OPERATING INSTRUCTIONS FOR NEUMANN CONDENSER MICROPHONES U 47/U 48 AND ACCESSORIES

Conversion of Neumann U 47 and U 48 microphones to nuvistor tubes

U 47-960-02-01

CONVERSION OF NEUMANN U 47 and U 48 MICROPHONES¹ TO NUVISTOR TUBES (nuvistor 13CW4 instead of tube VF 14M)

NG power supply schematic:

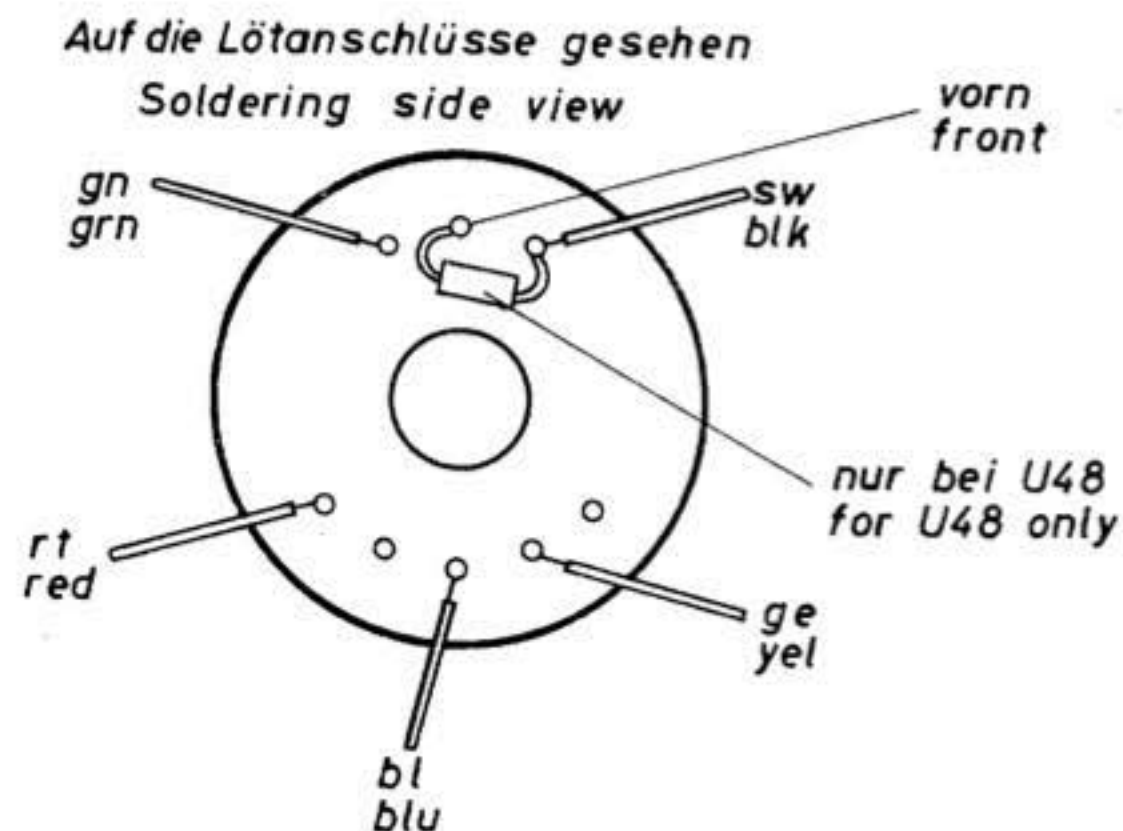
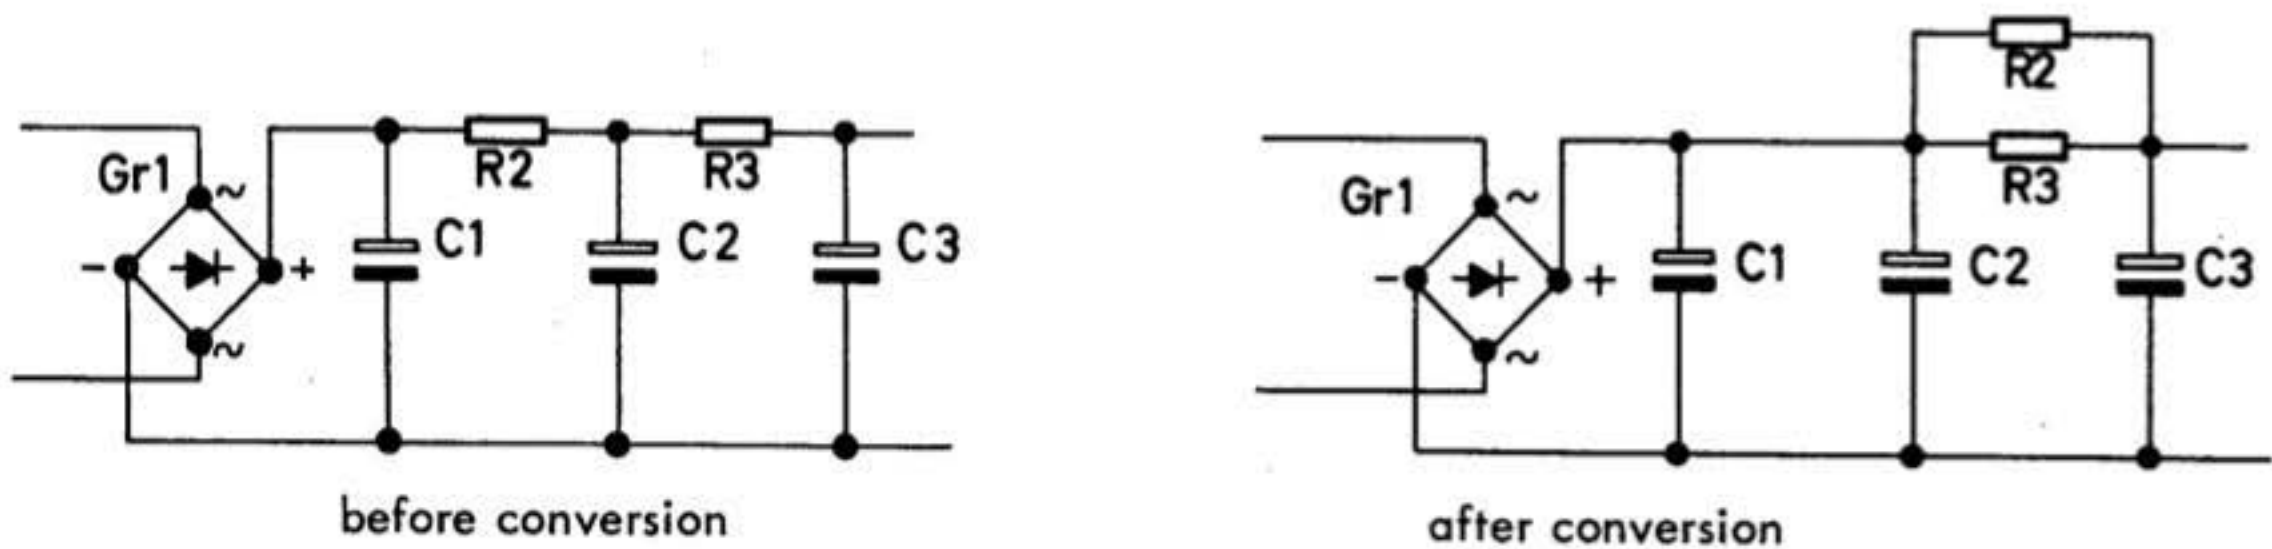
1. Remove VF 14.
2. Remove the leads (red, blue, yellow, green, black) from the tube holder (at U 48 remove also 29- Ω -resistor.).
3. Remove the tube holder after unscrewing six screws in the three bars.
4. Two of the three plastic holders supplied have to be inserted into the screw holes.
5. Put the AR 47 upside down into these holders and fix it by inserting the third plastic holder. (The AR 47 side with three soldering points shows towards the front of the microphone.)
6. Resolder the leads according to the sketch below (at U 48 resolder also the 29- Ω -resistor).
7. Insert nuvistor 13 CW 4 into the socket.

The NG pwer supply must have a small change of wiring due to the greater heater current required by the nuvistor.

- a) Replace resistor R-2 (1 k Ω power resistor coming from + terminal of rectifier) by a solid wire connection between the first two electrolytic capacitors.
- b) Install this same R-2 in parallel with R-3 (an identical resistor next in the RC filter chain), thereby making its total resistance value 500 Ω .

NG power supply schematic:

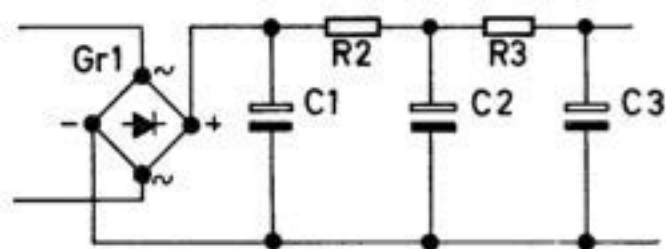
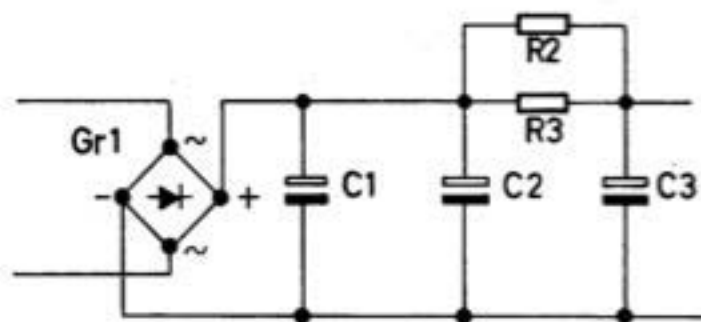
There are no other changes required in the microphone itself. The NG power supply, however, must have a small change of wiring, due to the greater heater current required by the Nuvistor.

- Replace resistor R-2 (1 k Ω power resistor coming from + terminal of rectifier) by a solid wire connection between the first two electrolytic capacitors.
- Install this same R-2 in parallel with R-3 (an identical resistor next in the RC filter chain), thereby making its total resistance value 500 Ω .
